CITY OF ALBUQUERQUE

December 29, 2023

**RE: 13701 Covered Wagon Ave SE
Grading and Drainage Plan
Engineer's Stamp Date: 12/19/23
Hydrology File: L23D014M**

ENGINEER'S SEAL	LOT 8-P1 COVERED WAGON SUB 13701 COVERED WAGON AVE.	DRAWN BY DEM
DAVID SOULE 14522 REGISTERED PROFESSIONAL ENGINEER	GRADING AND DRAINAGE PLAN	DATE 3-17-23
12/19/23	Rio Grande Engineering	13701 Covered Wagon Ave. DWG
DAVID SOULE P.E. #14522		SHEET # C1
		JOB #

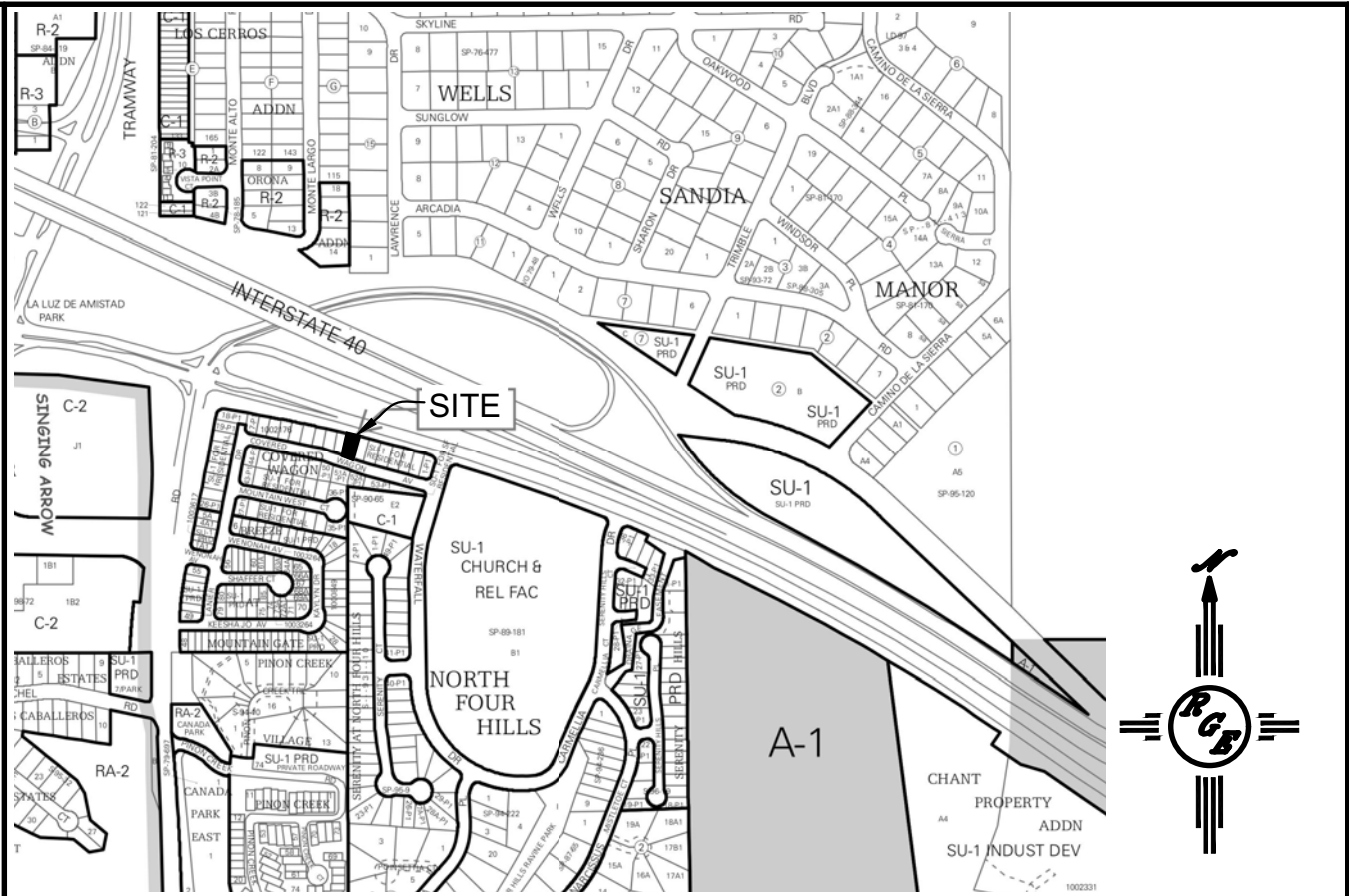
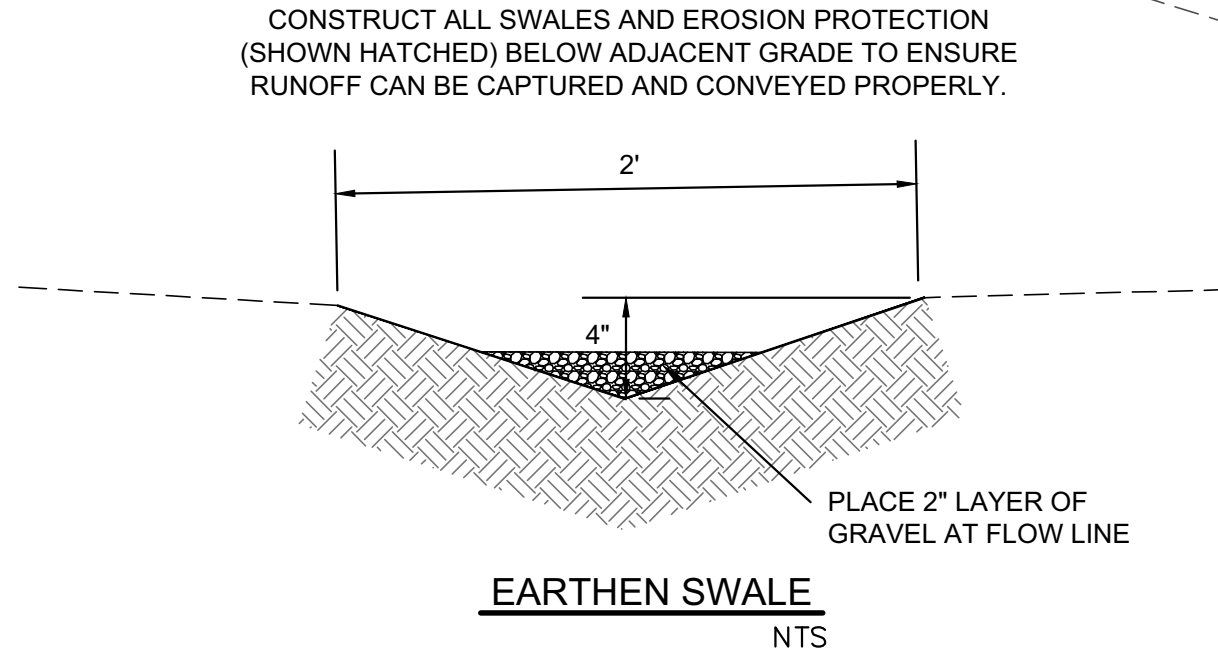
Based upon the information provided in your submittal received 12/19/2023, the Grading and Drainage Plan is approved for Building Permit and Grading Permit. **Since this site is relatively flat and grades to the road, a pad certification is not needed for this project.** Please attach a copy of this approved plan in the construction sets for Building Permit processing along with a copy of this letter.

1. Engineer's Certification, per the DPM Part 6-14 (F): Engineer's Certification Checklist For Non-Subdivision is required.
